FERN 20026497 input to ExA questions to the Applicant on Two Village Bypass

Sarah Green for FERN

2) Applicants answers to EDF's questions and some FERN comments in RED

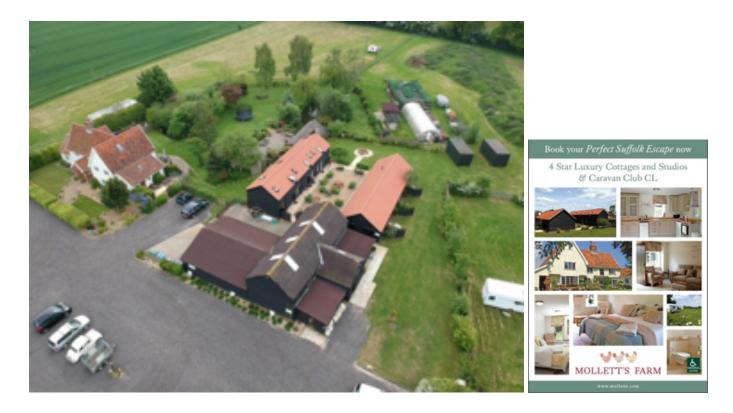
There is ONE residential property at Walk Barn Farm, it is a small farm bungalow of low architectural merit that is usually unoccupied but occasionally so for holiday lets or a very occasional visit by the owners, we understand. The alternative route would be behind this bungalow, behind a thick line of trees/hedge, the way the house orientates and the height of land levels mean it would have a lower adverse effect to the property than the current route does to many other properties.

We also question the 20m proximity that the Applicants claim the Eastern route would put on Walk Barn Farm. We have detailed plans of Option 14 that went East of Foxburrow Wood drawn up by the Highways Agency in a 1990 consultation (A1 plans which we could provide). This was for a proposed dual carriageway that went east of Foxburrow Wood. It was positioned about 90m from Walk Barn Farm, it did clip Foxburrow Wood by 10m, but was a dual as opposed to a single carriageway. We are not road builders but this 20m measurement appears mistaken.

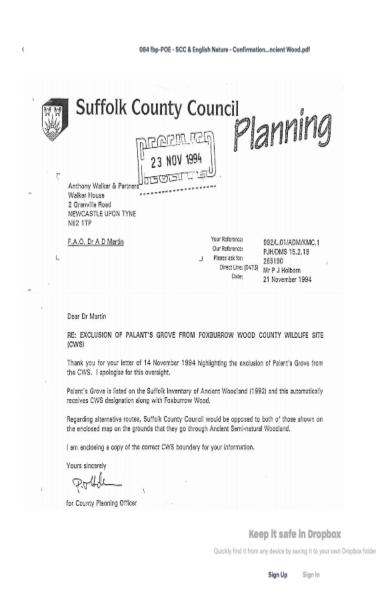
As we know only too well at FERN (and keep saying) the CWS was an automatic designation when the corridor between the woods was wrongly designated as Ancient Woodland some years ago; it has been reappraised by Natural England and the corridor between Foxburrow Wood and Palant's Grove has now been undesignated, as seen on magic mapping. By being no longer AW it calls into question whether it is properly CWS. That corridor is denuded and of little value because of its narrowness and proximity to intensive arable farming.
